SECTION 4.55 APPLICATION
33 UPPER CLIFFORD AVENUE
LOT C DP 102834 FAIRLIGHT
DA166/2015

S4.55 APPLICATION DRAWING LIST

DEVELOPMENT CONSENT DA-166/2015
NORTHERN BEACHES COUNCIL
DEVELOPMENT MODIFICATION MOD2018/0715
BASIX CERTIFICATE No A336197_03

S4.55 APPLICATION
ADDITIONS & ALTERATIONS
33 UPPER CLIFFORD AVENUE
FAIRLIGHT

**BUILDING ELEVATION
SHEET 2**

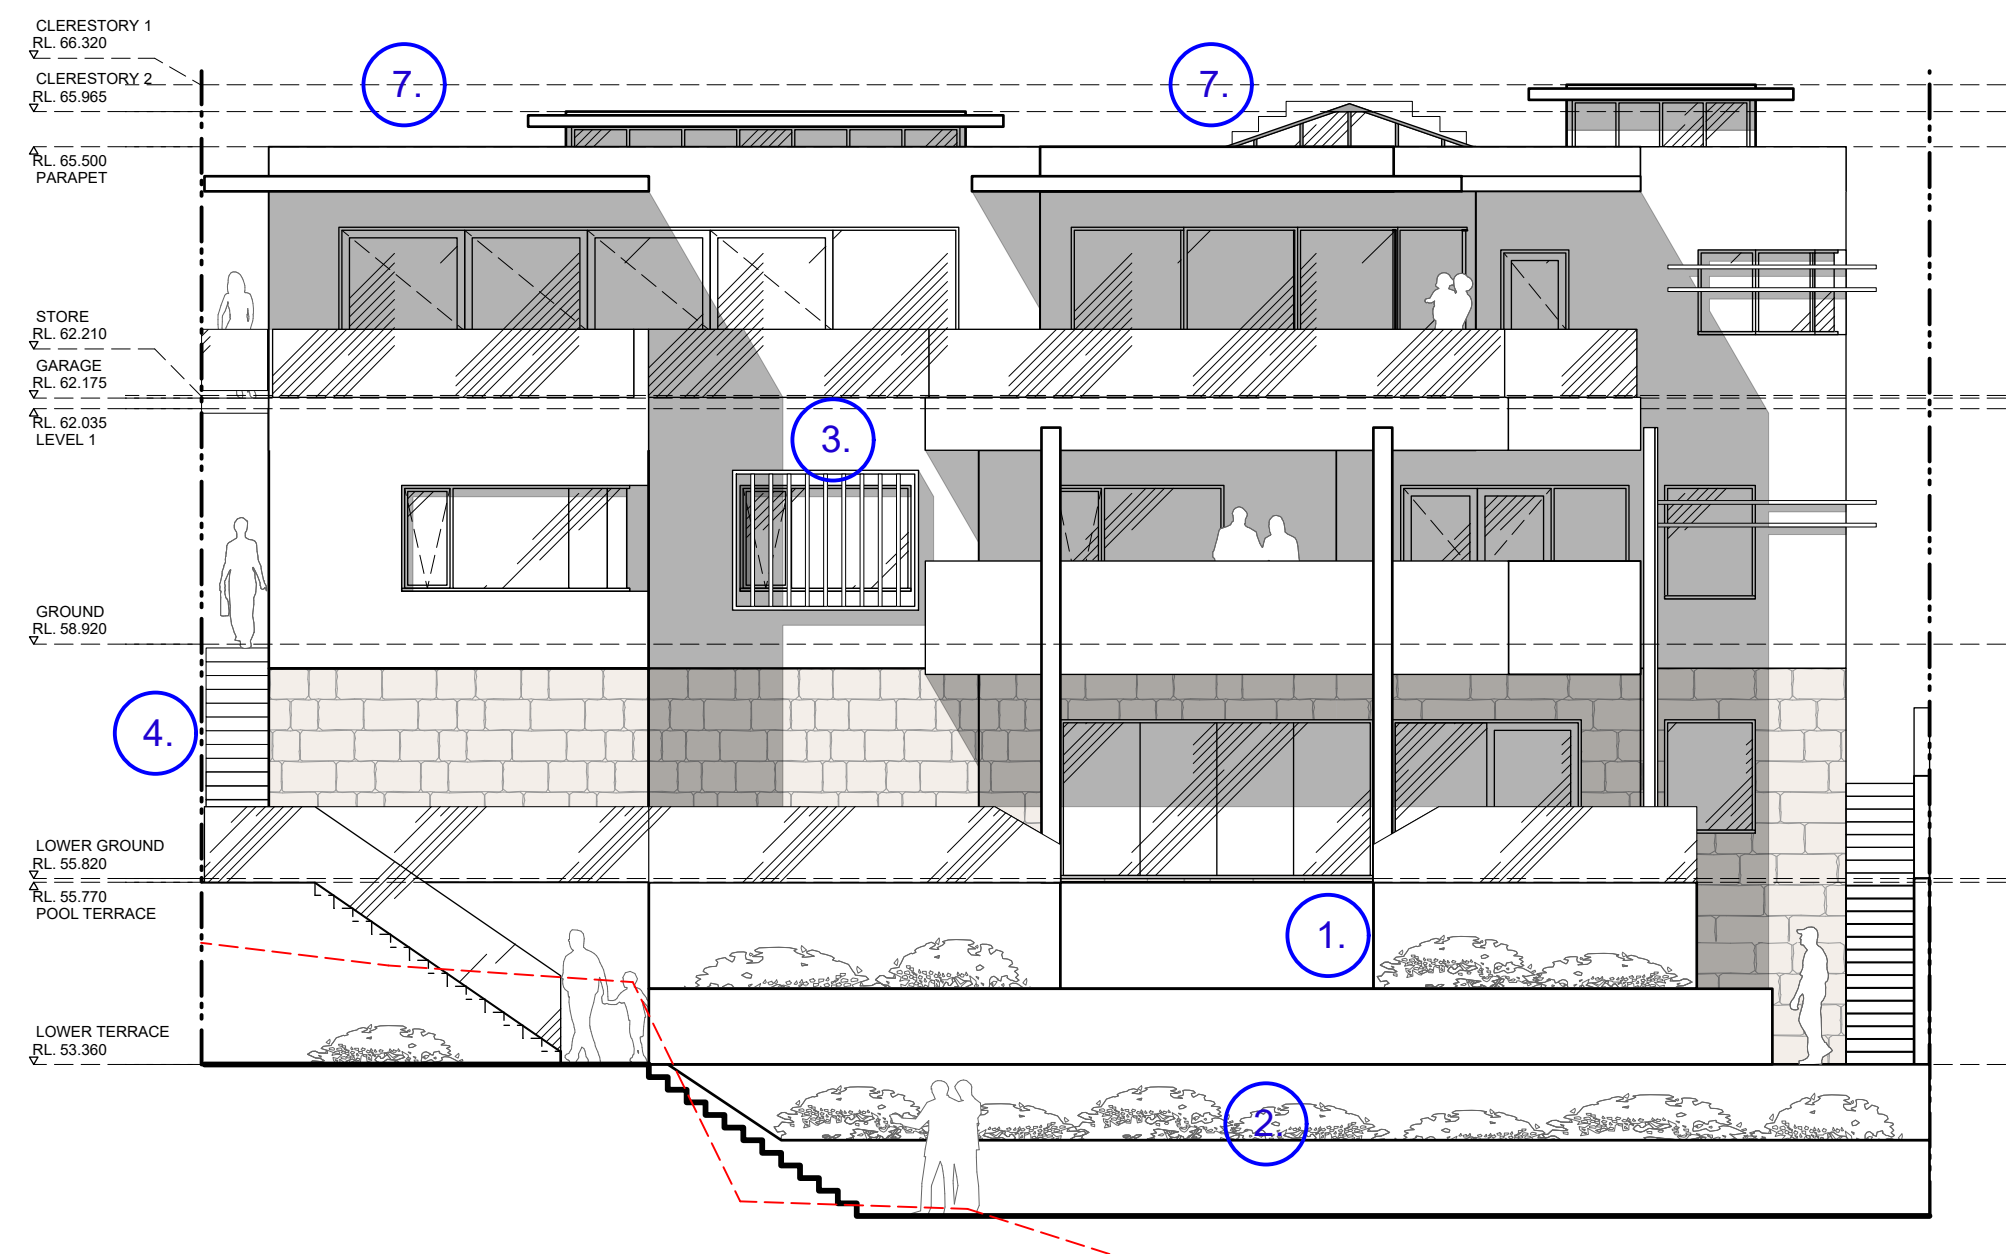
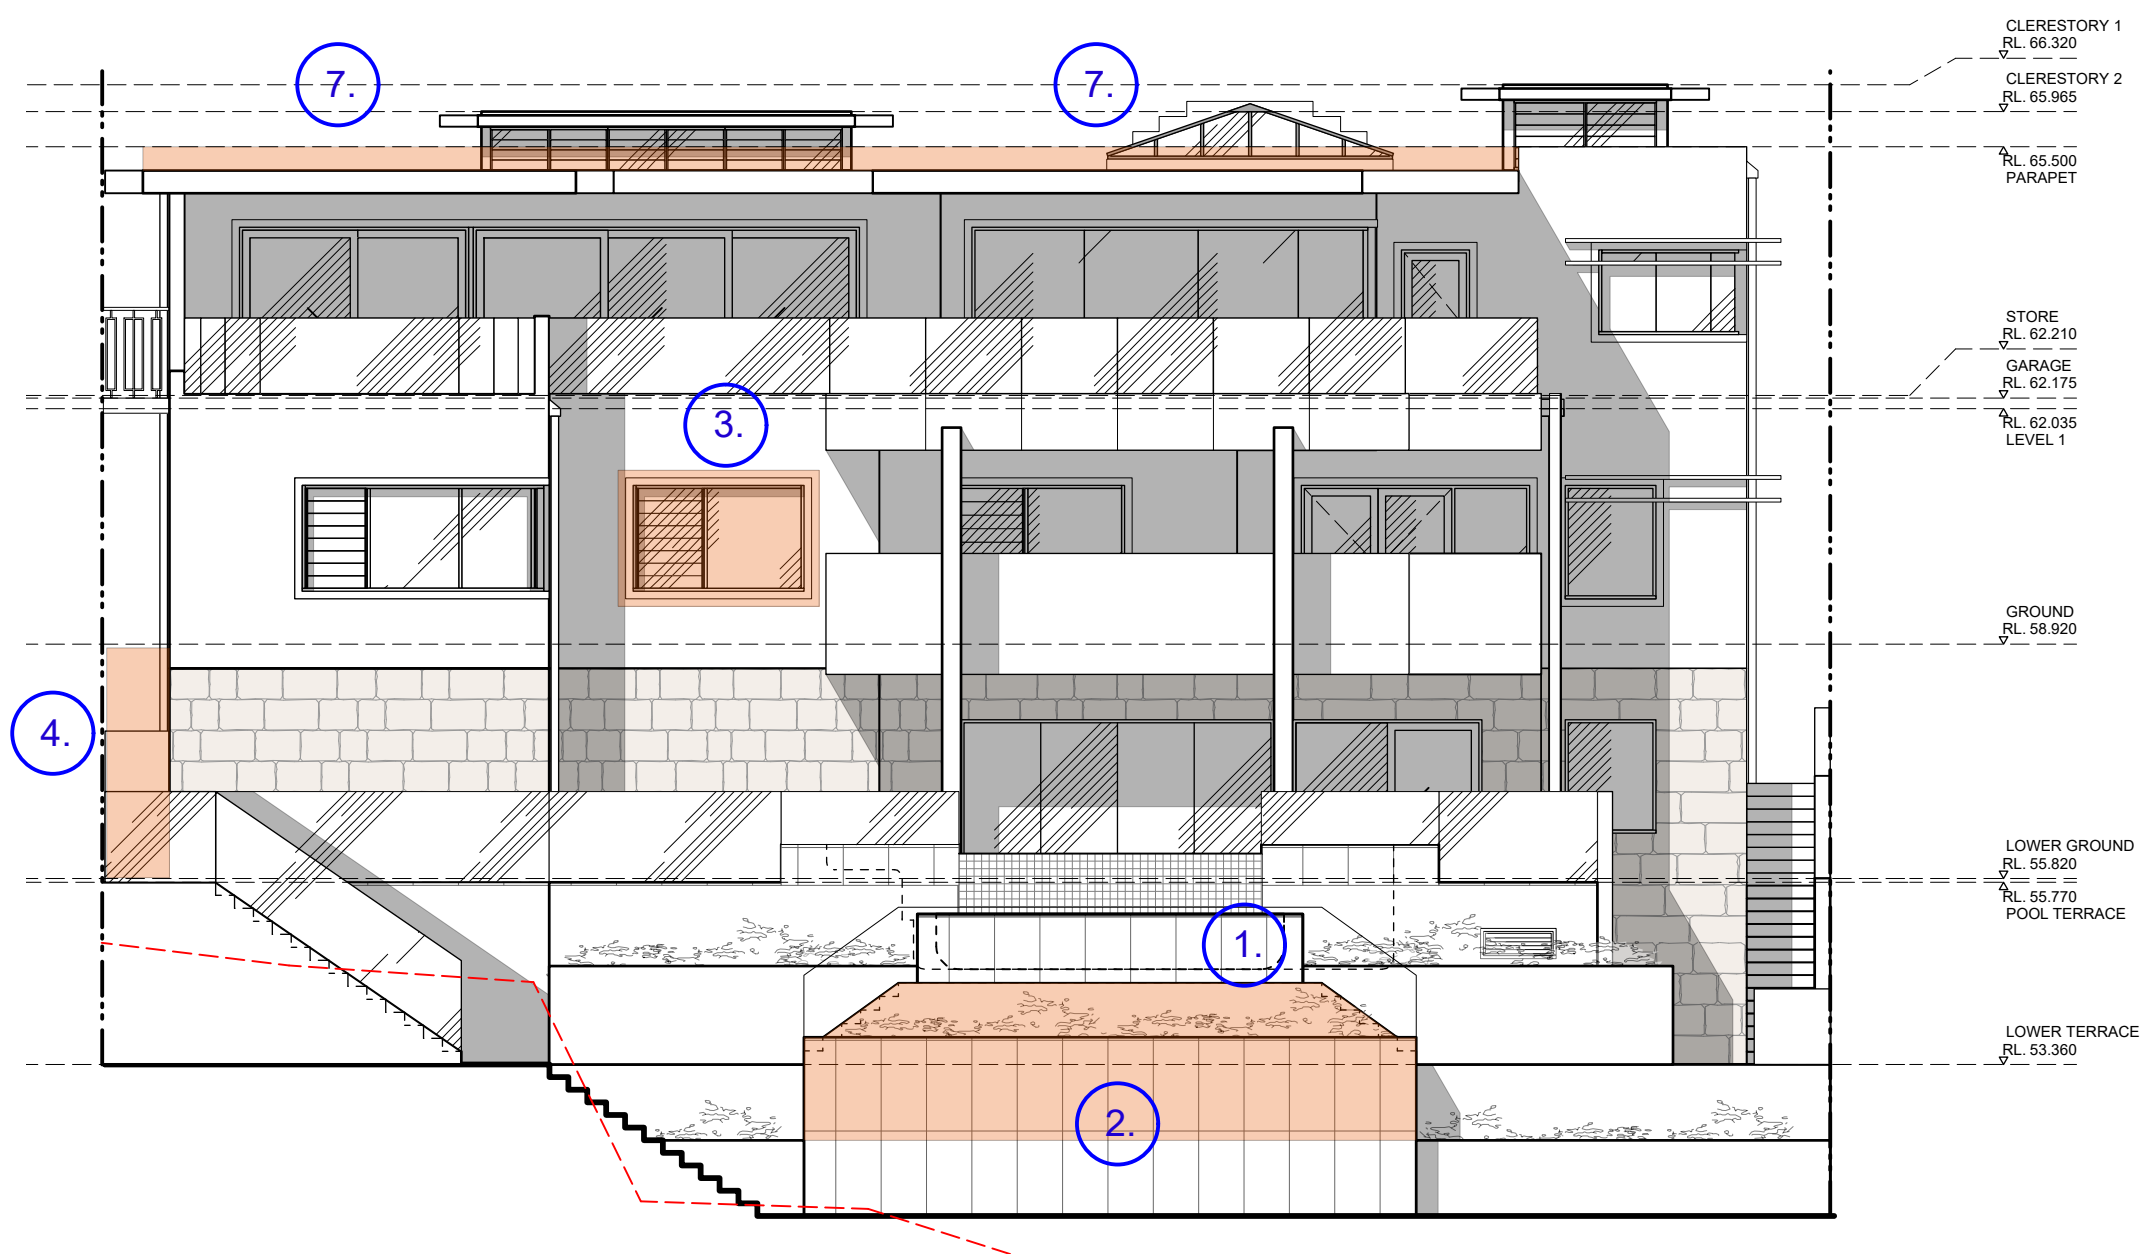
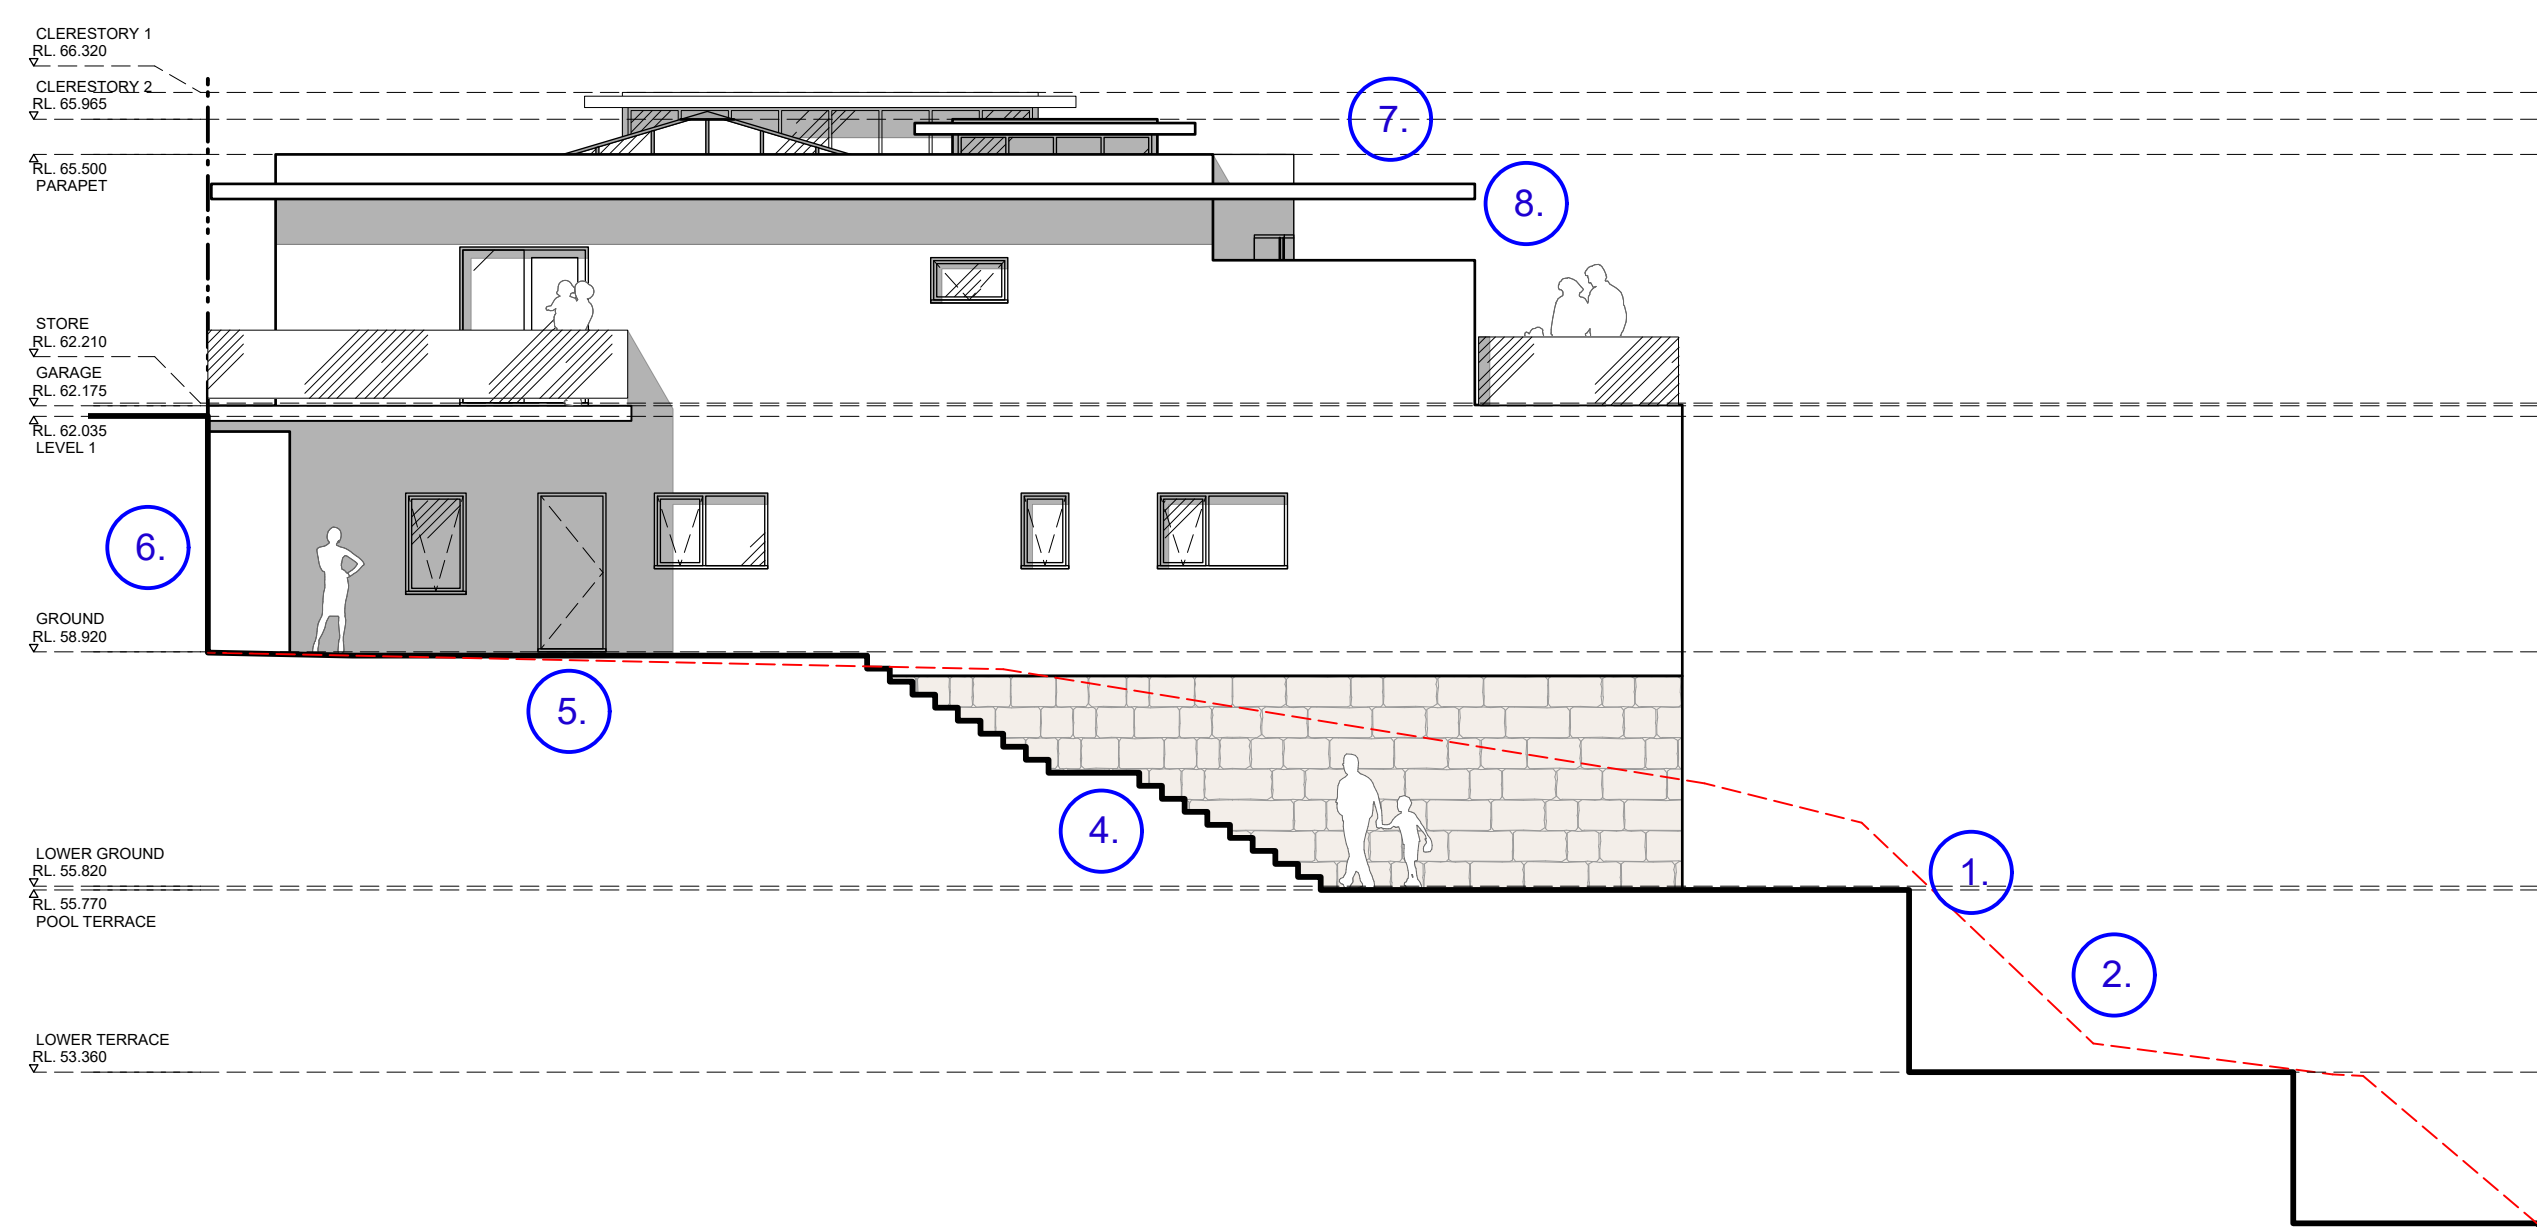
1. ADDITION OF LEVEL CHANGE TO TERRACE PATHWAY
2. MINOR CHANGE TO RETAINING WALL
3. REMOVE MASTER WIR WINDOW AWNING
4. REMOVE WESTERN STAIR ACCESS
5. REMOVE EXTERNAL ACCESS FROM BED 2
6. RELOCATE RAIN WATER TANK
7. UPDATE ROOF DESIGN TO COMPLY WITH PREVIOUS S4.55 CONDITIONS - REMOVE PART OF PARAPET
8. UPDATE BALUSTRADE DESIGN TO PREVENT POTENTIAL CLIMBABLE SURFACE HAZARD
